**To:** Vit, Wendy[wendy.vit@dnr.mo.gov]  
**Sent:** Tue 8/11/2015 3:40:07 PM  
**Subject:** RE: Interactive Source Question Follow Up

**From:** Hawkins, Andy [mailto:hawkins.andy@epa.gov]  
**Sent:** Tuesday, August 11, 2015 9:08 AM  
**To:** Keas, Ashley  
**Cc:** Wilbur, Emily; Vit, Wendy; Avey, Lance; Algae-Eakin, Amy; Gonzalez, Larry; Jay, Michael  
**Subject:** RE: Interactive Source Question Follow Up

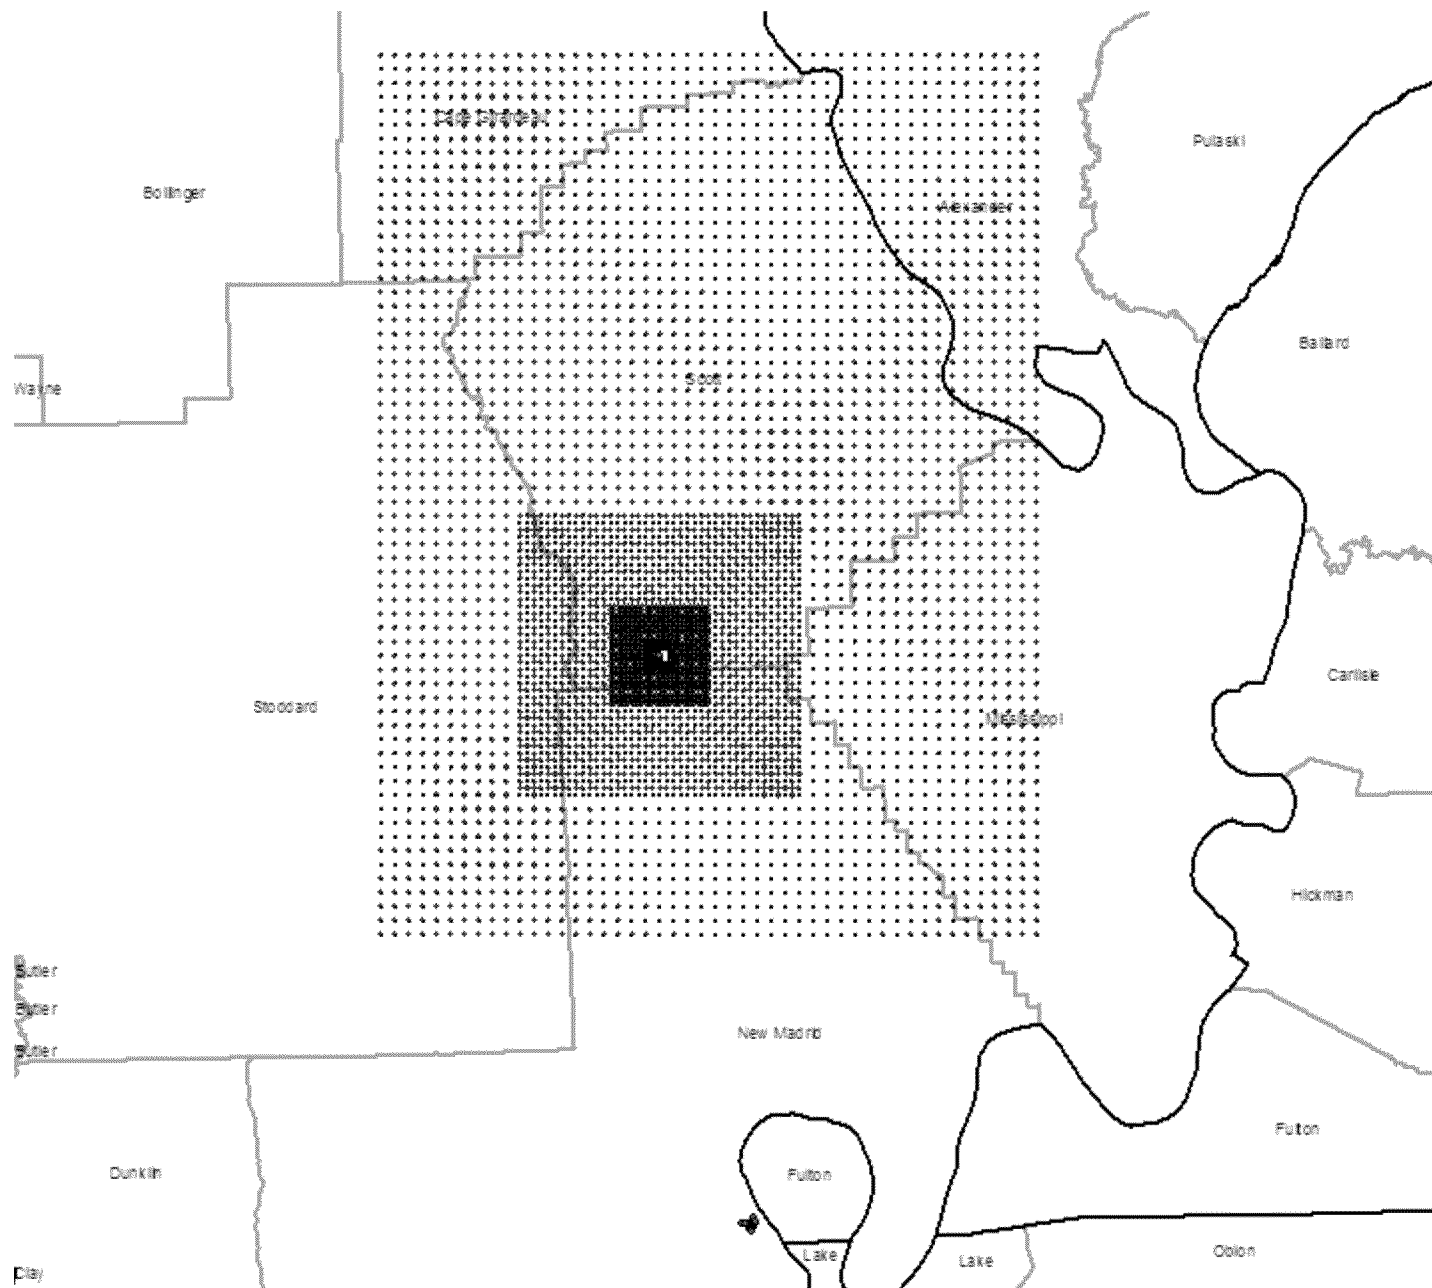
Here are the sources in arcmap for the input file I have, so receptors look fine, but the interactive sources are all bunched to the south (all new madrid I guess). So this means that Buzzi Unicem is not modeled explicitly? It's very close to the proposed attainment area to the north. In the SIP document it says Buzzi is modeled but it does not show up when I map it in the location I expect it at anyway. So please check Buzzi... could be my input file or maybe my import does not work correctly. So the new madrid locations may all be correct, maybe Buzzi is just not in the

input?

You are correct. We inadvertently sent you an outdated input file since we had multiple people doing the last minute runs. I will have someone FTP the correct files to you tomorrow.

Sorry about that. Thanks for bringing it to our attention. We are correcting the modeling file Appendix too.

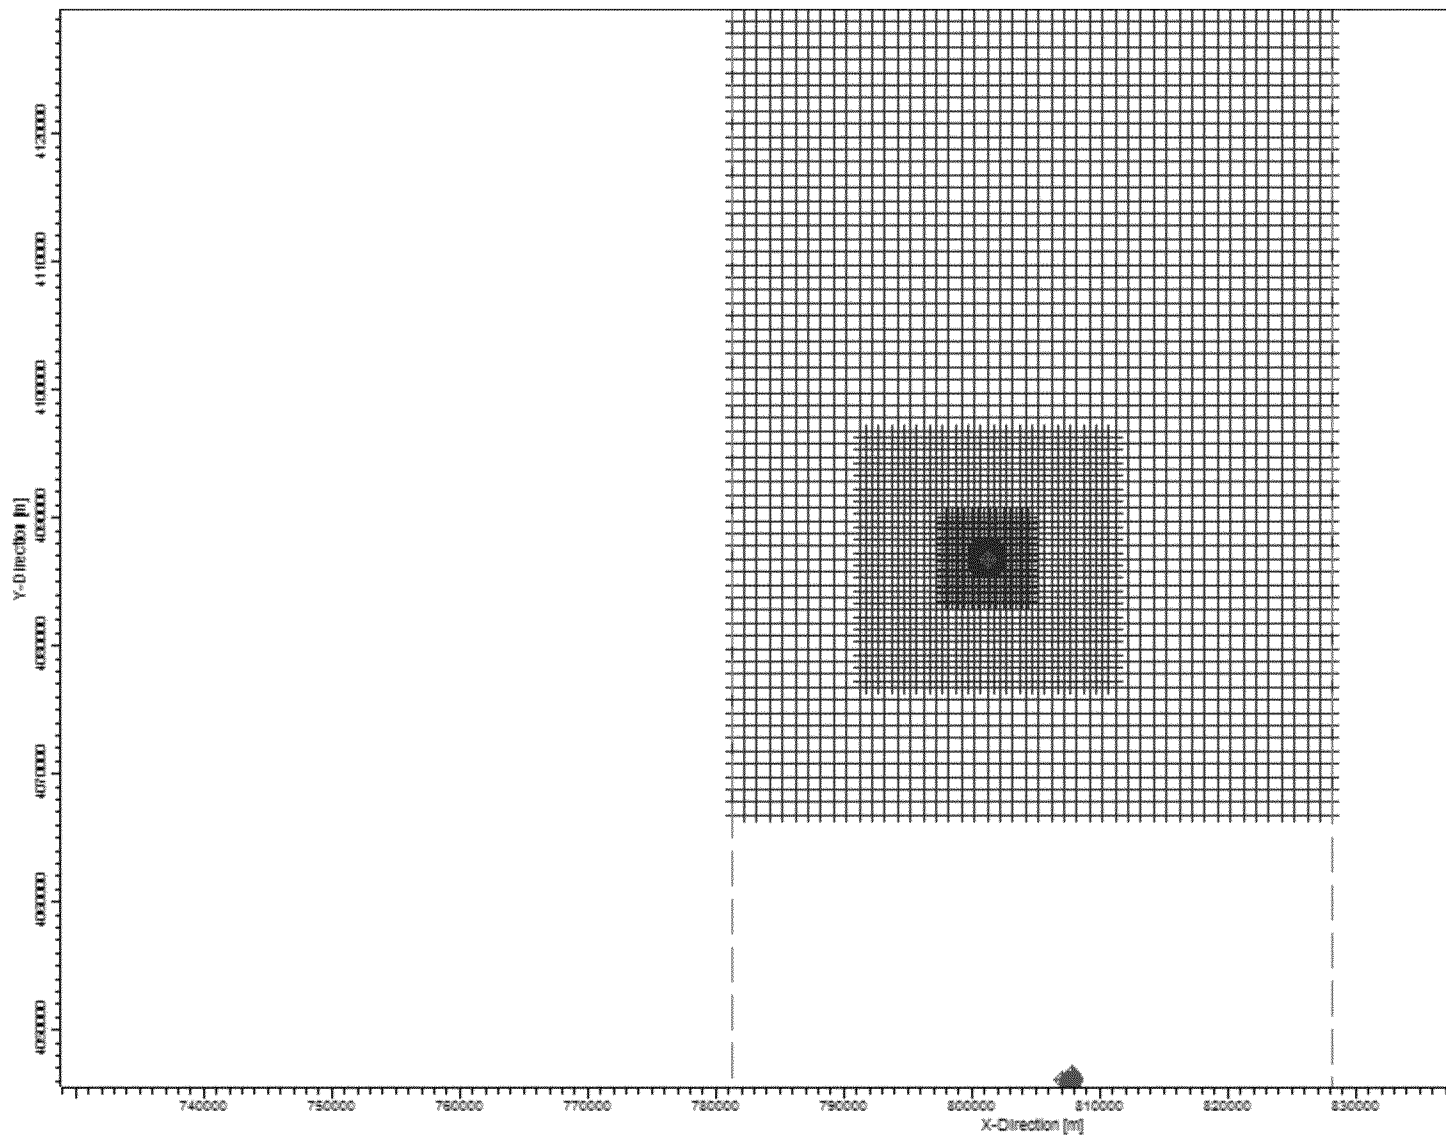
Can you please verify the Sikeston interactive source locations in the AERMOD input file you sent... the locations of the interactive sources look questionable when I import them using the supplied input file for this CD source.
